REGULAR MEETING • AGENDA

- 10.3. PB2025-02 Ralph Mocchi
Block 72, Lot 4.04
6 Blue Point Cove Road
Proposed use and bulk variance approval for an addition to add housekeeping quarters

**RE: Board Application PB2025-02
Use & Bulk Variances
Applicant/Owner: Ralph Mocci
6 Blue Point Cove Road, Block 72, Lot 4.04
Oceanport, Monmouth County, NJ
First Engineering Review**

1 PLOT DIAGRAM
SCALE: 1" = 10'-0"

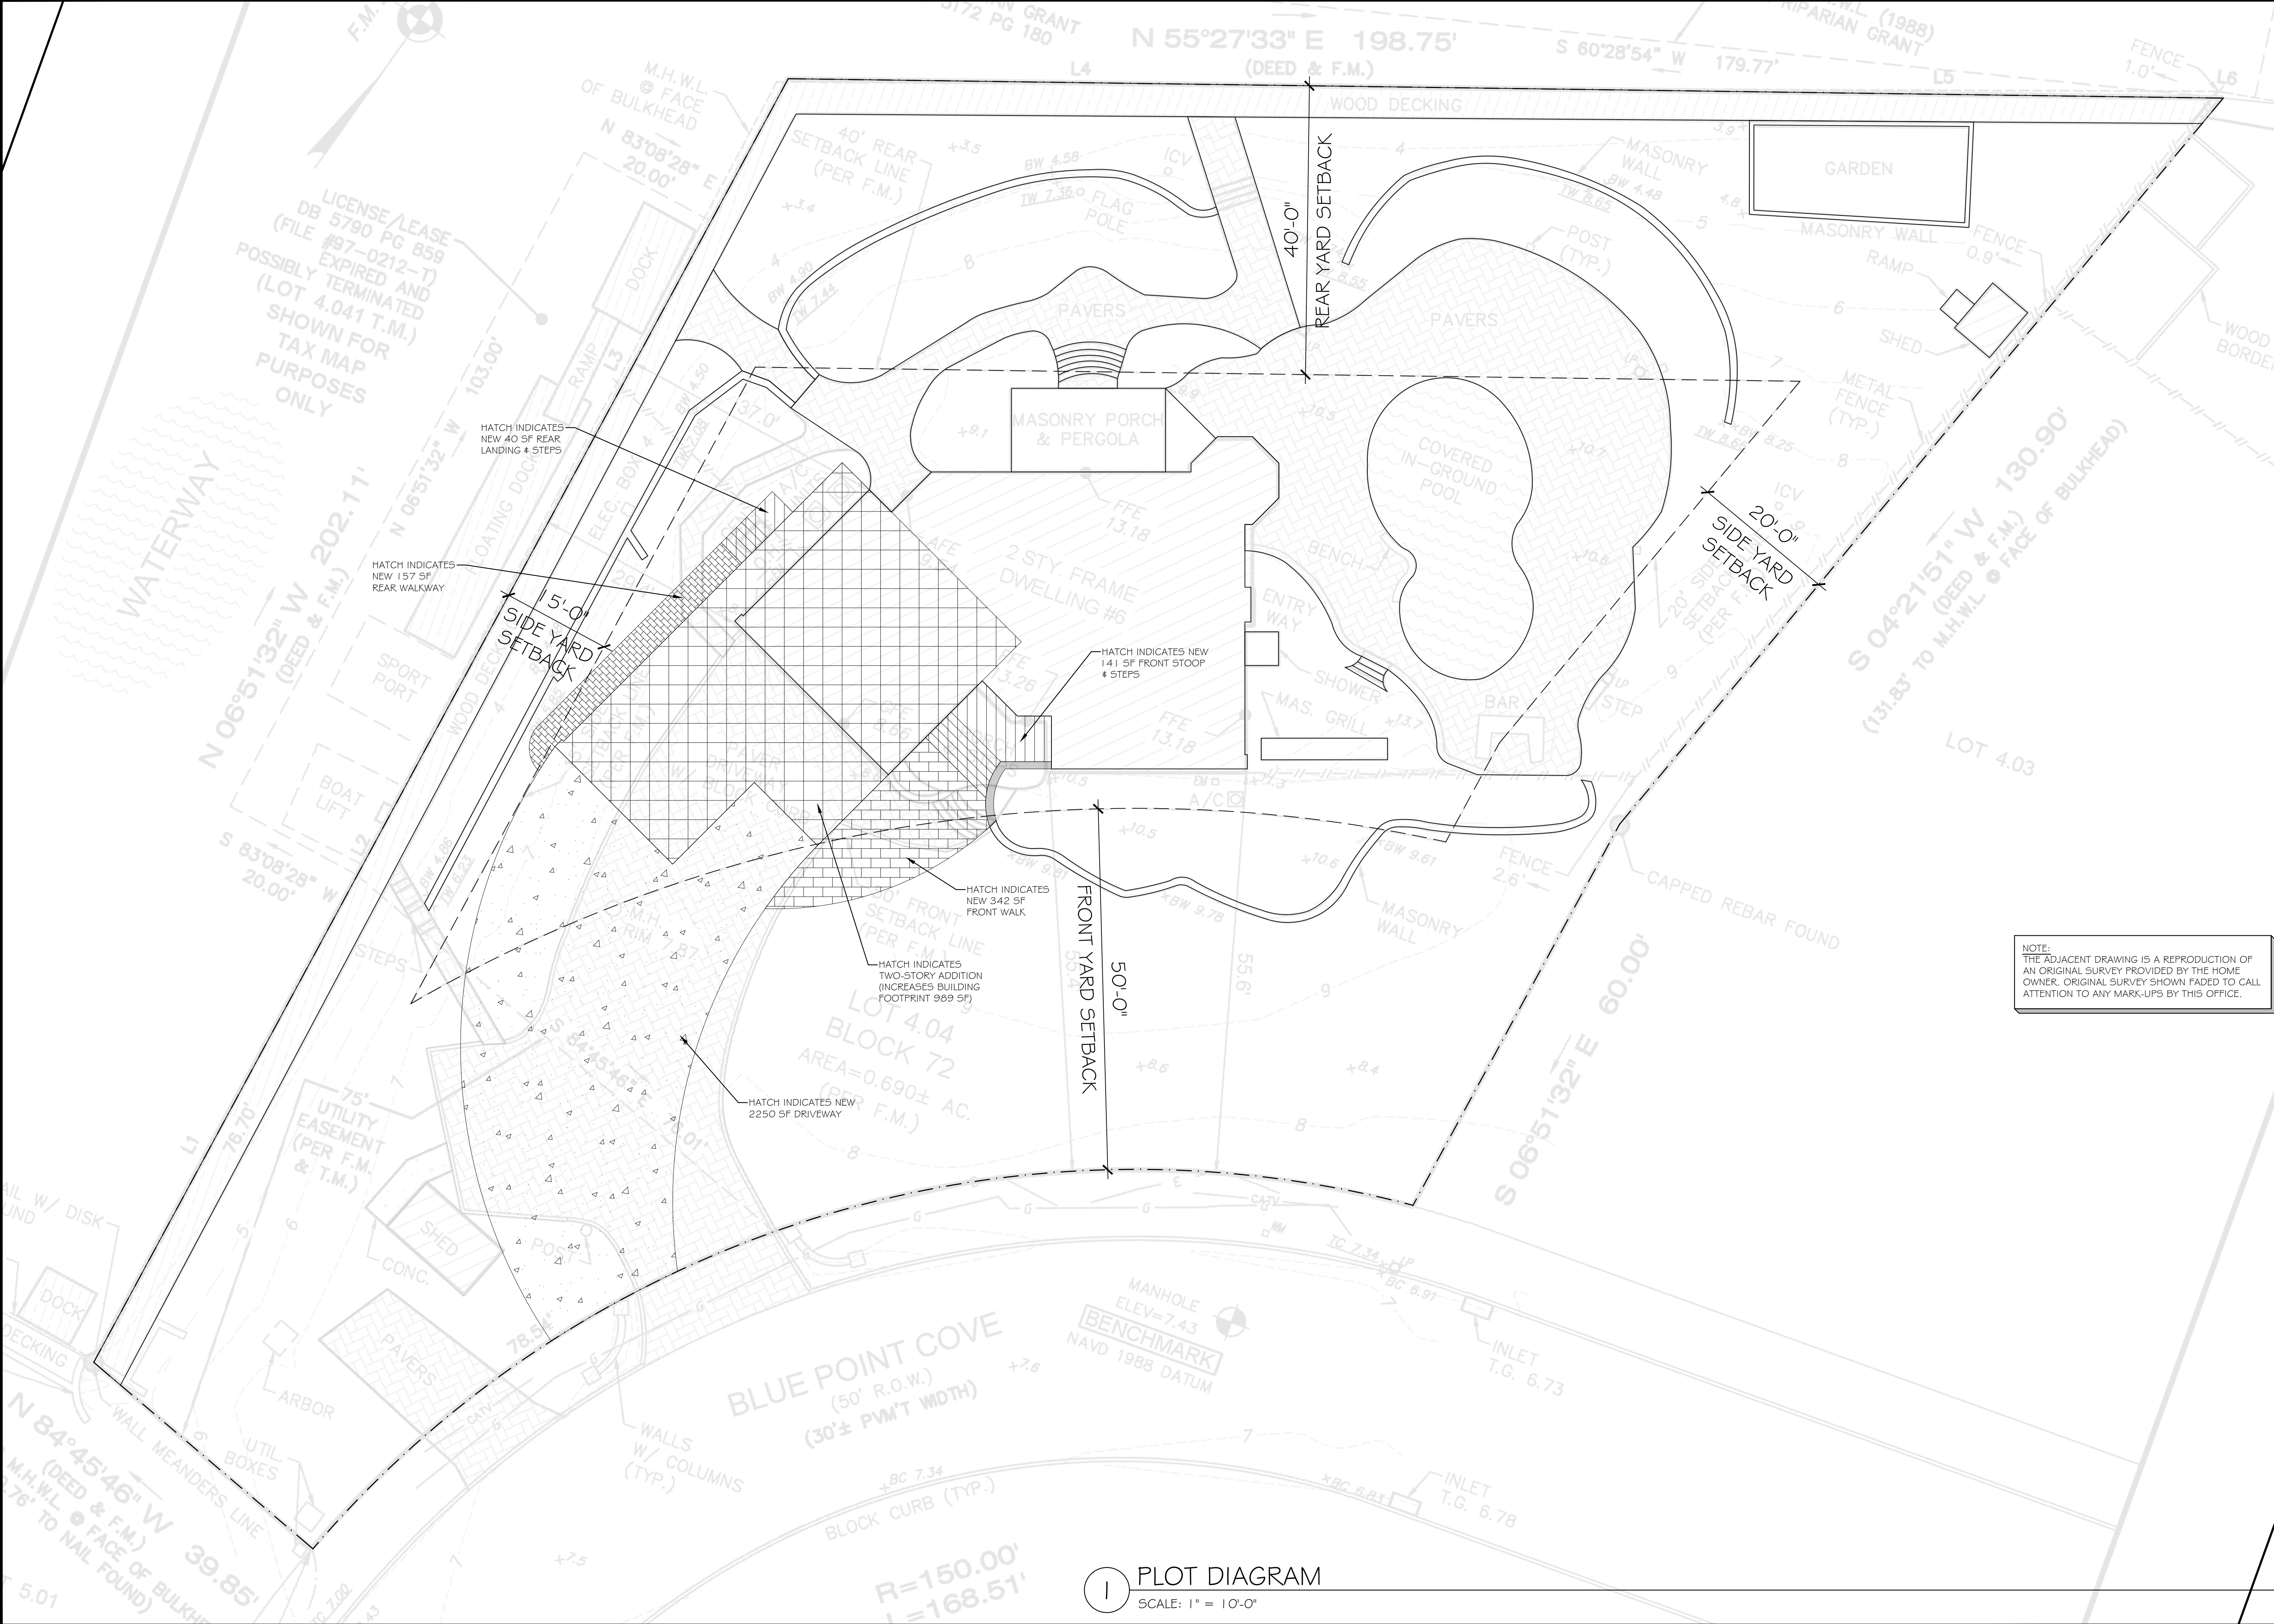
- 4.1 The proposed impervious lot coverage adds up to 11170 SF, however the table lists 12,779 SF. The 37.2% lot coverage is correct; however, the applicant should confirm the calculation in the table.

- 4.2 The site is in an AE Zone with a flood elevation of 10 ft NAVD 88. The plans should list the BFE of the structure. We defer to the Borough's Floodplain Manager for review.

- 4.4 Locations of roof leaders should be shown on plan.
- 4.5 The plans indicate that retaining walls will be modified (note 3). The plans show top and bottom wall elevations indicating the wall is 4.2 feet in some areas. Since over 3 ft in height, wall calculations may be required by the construction official. A detail should be provided of the wall.

- 6.1 Details should be provided for the apron, curb, and pavement repair in the Borough right-of-way as well as any utility repair details.
- 6.2 The plans show a 75 ft utility easement and the driveway is existing and proposed within this easement. The applicant should provide a copy of the easement and clarify whether the driveway is permitted within the same. We just want to confirm no issues with access to the driveway/garage in the future since the driveway crosses this easement.
- 6.3 This application may be subject to the following outside agency approvals:
 - A. Freehold Soil Conservation District- the plans show an LOD disturbance over 5,000 SF, plans show 14,300 SF of disturbance.
 - B. Oceanport Environmental Commission- if required.
 - C. Oceanport Floodplain Manager
 - D. Fire Official
